Title: Accept Low Evaluated Bids for Automation System Software and Equipment

**Subject: Distribution Automation Switchgear Purchase Recommendation
S31-10A**

12.47 kV Overhead Reclosers and Padmounted Reclosers or Padmounted Switchgear

Subject – Response to questions and clarification in letter dated October 29th, 2010
regarding St. Charles Distribution Automation Equipment

Item B1 – Padmount Recloser

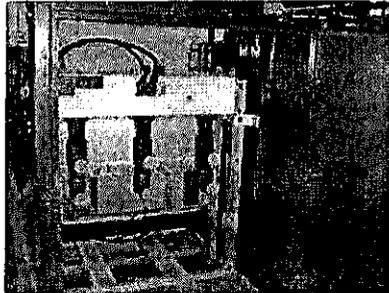
1. All of the questions from Item A, also need to be addressed for Item B1
See above.
2. Your bid is an alternate to what was specified. You took advantage of the fact that the Viper is molded with 600A apparatus bushings. The challenge is how to connect voltage sensors on the side opposite the internal voltage sensors and how to connect a voltage transformer on each side to power the control. The three plug-in Lindsey sensors you propose would seem to eliminate the possibility of a 200A interface on the back of the 600A elbow termination on one side of the recloser. Do you have a suggestion for where we could install elbow surge arresters on that side?
Although a solution with Lindsey sensors would function properly, it would require some "gymnastics" inside the enclosure, so G&W would propose to offer an

alternative solution using 4 solid dielectric PTs. With 4 PTs, each connected to a 200 amp interface on the back of the 600 amp elbow termination, you would have a dead front source of voltage and, where needed, 120 volt AC power. G&W can offer this solution at the quoted price.
